IV. CORRECTIONS AND ADDITIONS

CORRECTIONS AND ADDITIONS TO THE DRAFT EIR

LAX Sign District Project EIR

II-6

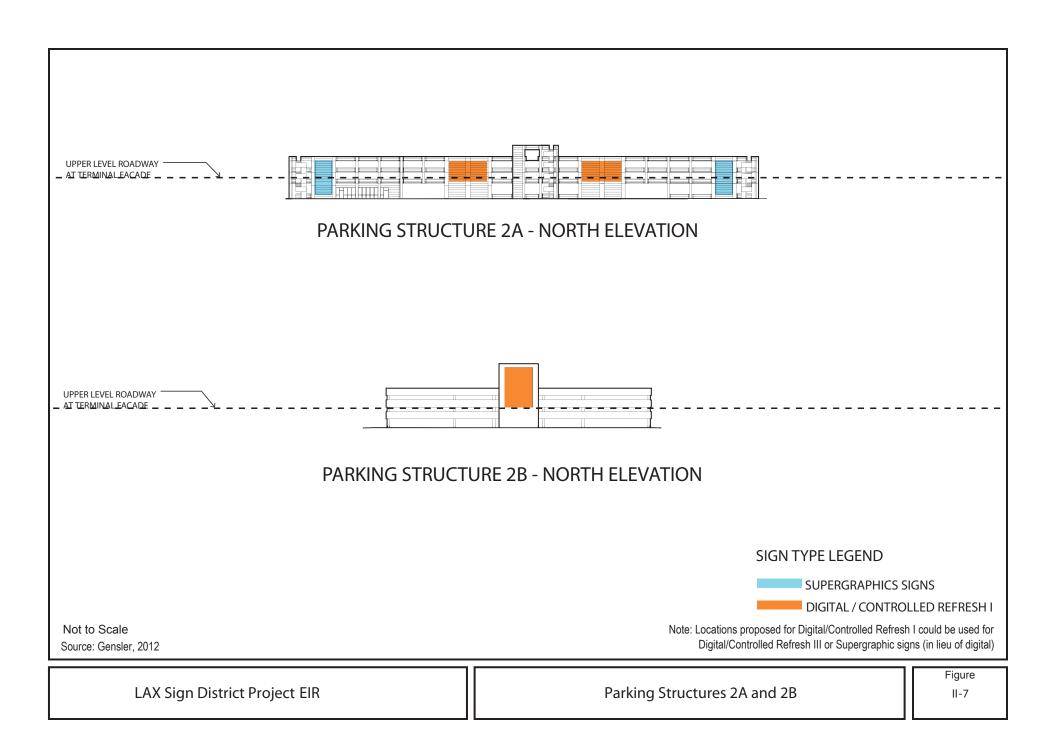
The following figures in Chapter II Project Description have been updated to provide clarification regarding locations proposed for Digital/Controlled Refresh I (refresh every 8 seconds, with the exception of Parking Structure 1 – East Elevation, which has a refresh of every 14 seconds), which (as described in the Draft EIR) can be used for Digital/Controlled Refresh III (refresh every 12 hours) or supergraphic signs in lieu of digital:

- Figure II-6 Parking Structure 1
- Figure II-7 Parking Structures 2A and 2B
- Figure II-8 Parking Structures 3 and 4
- Figure II-9 Parking Structures 5, 6, and 7

The revision is as follows, under the "note" annotation (bottom right corner of graphics):

Note: Locations proposed for Digital/Controlled Refresh I could be used for <u>Digital/Controlled</u> <u>Refresh III or Supergraphic signs (in lieu of digital)</u>.

II-11

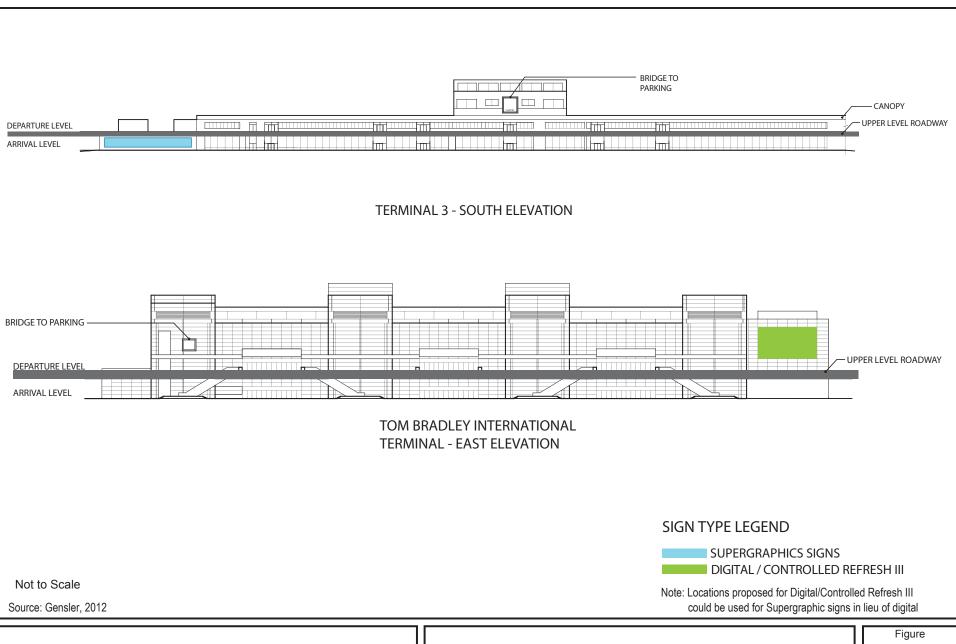
The following figures in Chapter II Project Description have been updated to correct errors regarding the note on Digital/Controlled Refresh III locations being used for Controlled Refresh I:

- Figure II-10 Terminals 1 and 2
- Figure II-11 Terminals 3 and TBIT

The revision is as follows, under the "note" annotation (bottom right corner of the graphics):

Note: Locations proposed for Digital/Controlled Refresh III could be used for Controlled Refresh I-or-Supergraphic signs in lieu of digital.
